Product Change Notification - SYST-11NVEM452

Notification subject: ERRATA - LAN8741A/LAN8741Ai - Silicon Errata and Data Sheet Clarification Errata Document Revision

LAN8741A/LAN8741Ai Silicon Errata and Data Sheet Clarification

FIGURE 1: TOP MARKING FOR FUNCTIONAL REVISION A DEVICE

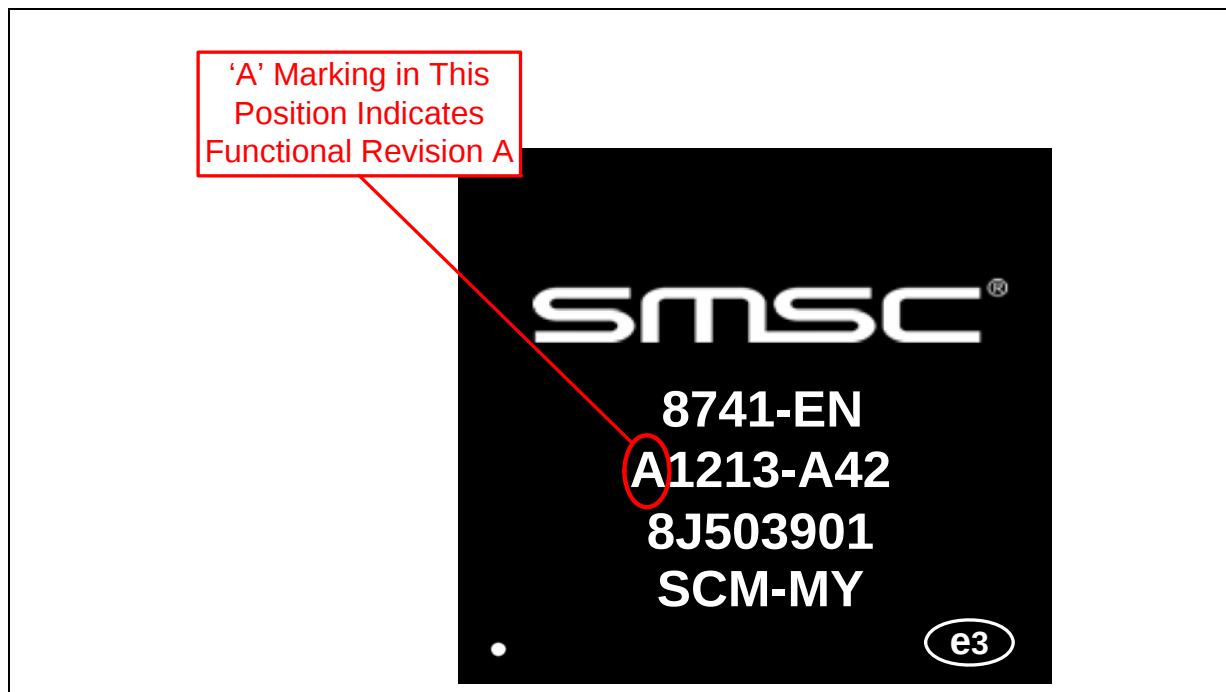
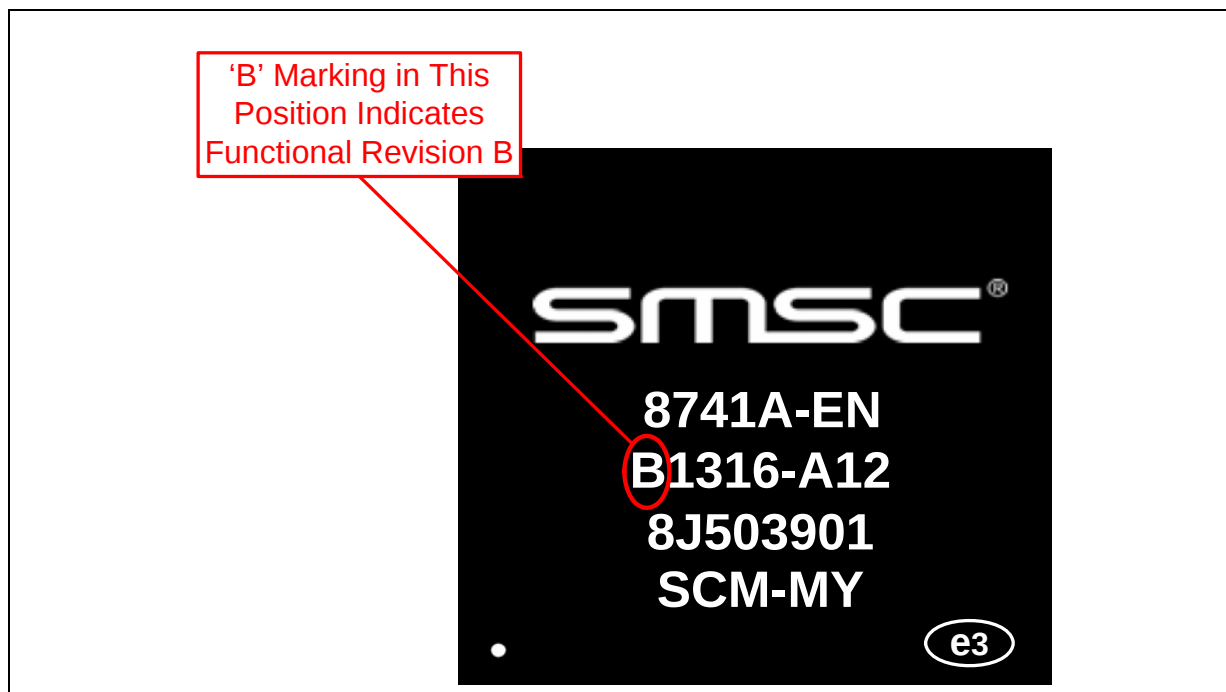
This document describes known anomalies for functional revision A and B of the LAN8741A/LAN8741Ai device. The functional revision can be determined by its top marking as indicated in [Figure 1](#) and [Figure 2](#).

For the purposes of this anomaly sheet, the part number indicated throughout the document includes an "A". Though only functional revision B parts contain an "A" in the device part number, this anomaly sheet also applies to the LAN8741 parts. The "A" in the part number is not indicative of the functional revision. Refer to [Figure 1](#) and [Figure 2](#) for the proper identification of the functional revision of a given device.

FIGURE 3: EXAMPLE EXTERNAL CRYSTAL CIRCUIT

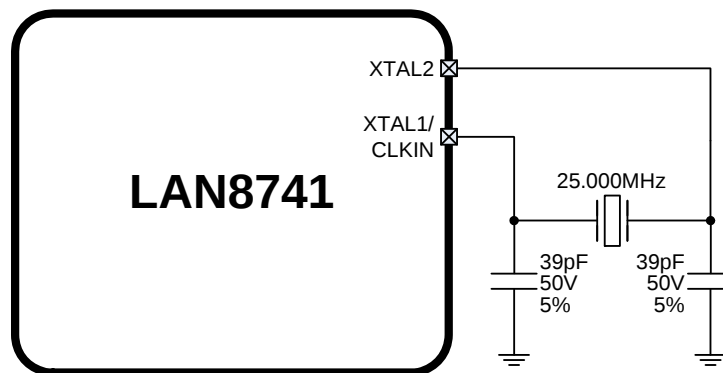
In EEE mode, the device may drop link when using a Broadcom BCM53125 link partner at cable lengths less than 20 meters.

When using a Broadcom BCM53125 link partner in EEE mode, the device may drop link when using cable lengths less than 20 meters. The BCM53125 has exhibited a sensitivity to minute deviations in its link partner's transmit clock frequency during 100Mb EEE operation. This issue is exacerbated at short cable lengths. This anomaly does not impact 10Mb or non-EEE operation.

1. Utilize an Ethernet cable length of greater than 20m.
2. Increase the load capacitors on the LAN8741A/LAN8741Ai external crystal circuit to 39pF and exercise best practices for board layout. Refer to [FIGURE 3](#): for an example external crystal circuit.

3. Use a single-ended 25MHz clock source that meets the LAN8741A/LAN8741Ai specification requirements in lieu of a crystal.
